Our ref:DOC25/956585

Your ref: SSD-10269-Mod-1

Narrabri Underground Mine Stage 3 Extension – Modification 1 – Request for Further Information

Figure 1: Map showing subsidence ponding areas. The associated offsetting credits are proposed to be reallocated from Stage 6c in the east of the project area to Stage 6b in the west.

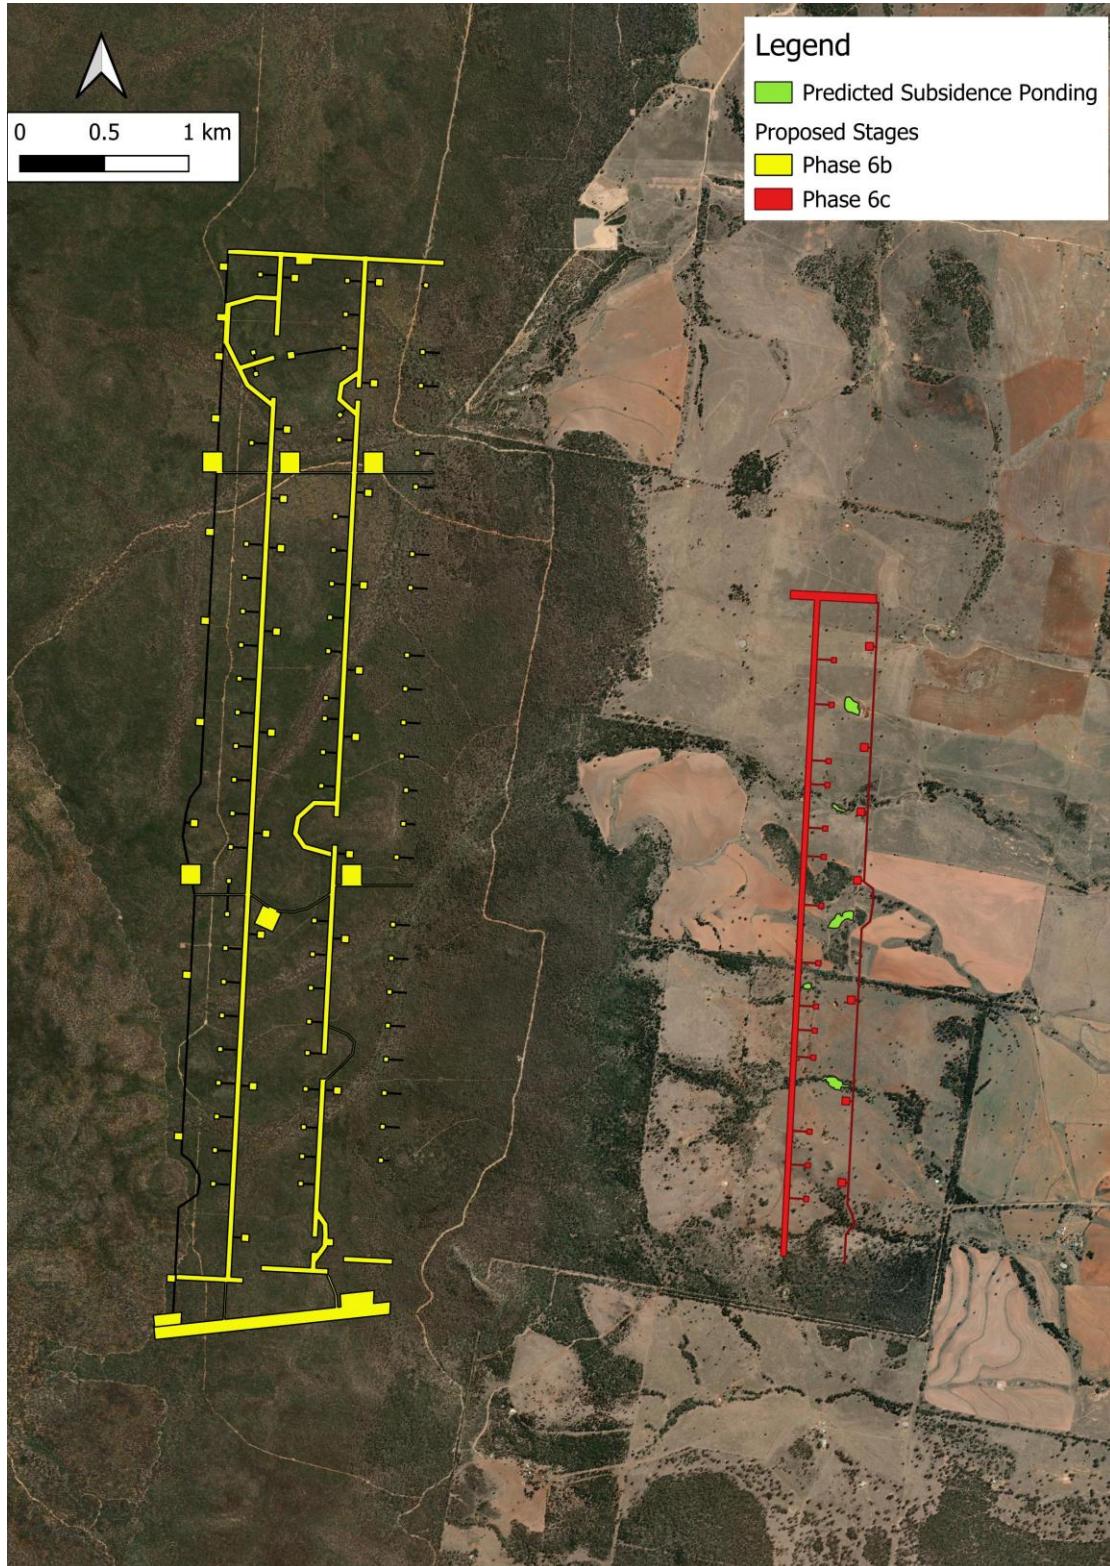
Following correspondence between CPHR, DPHI and the proponent, it has been explained that the RTS also introduces a new offsetting approach to proposed stages 6b and 6c. This involves aggregating subsidence ponding impact credits from Stage 6c into Stage 6b, effectively shifting credits from impact areas in the eastern portion of the project to an unrelated stage in the west (see Figure 1 below). The rationale for this approach is to ensure all ponding impacts are offset prior to their occurrence, as part of a conservative offsetting strategy. No operational requirements have been identified by the proponent to justify the need for this approach.

It is important to note that the requirement to offset Stage 6c prior to any impacts occurring would still apply, regardless of whether credits are shifted to an earlier stage. Whilst CPHR has no objection to the proponent choosing to pre-emptively offset impacts, the proposed redistribution of credits introduces a disproportionate level of complexity for the very small impact area it involves - 2.4 hectares, representing less than 0.4% of the project's total impact footprint.

Despite the minor scale of the ponding areas, redistributing and aggregating credits across unrelated stages will make tracking and auditing credit retirement increasingly difficult and time-consuming for both DPHI and CPHR. This complexity will be further exacerbated if credit retirement for stages 6b and 6c are later further modified under Condition B40 of the project's consent.

Given the absence of a clear operational need for the proposed credit redistribution, the disproportionate complexity it introduces and the fact that not redistributing credits would still ensure the project's legislative obligations are met, we recommend that the ponding impacts associated with stage 6c are not aggregated into stage 6b.

- 1.1 Credits for ponding impacts within stage 6c should not be aggregated into 6b.
- 1.2 DPHI note that there are credit errors in the MOD 1 report (dated June 2025) and the RTS report (dated July 2025). CPHR have replicated the correct credit calculations (excluding proposed aggregations between phases 6b and 6c) in **Attachment A**.
- 1.3 If DPHI consider accepting the proponent's proposal to aggregate credits, we would like to discuss a relevant condition with DPHI to ensure that the aggregated impacts in Stage 6b are offset prior to any clearing occurring within Stage 6c.
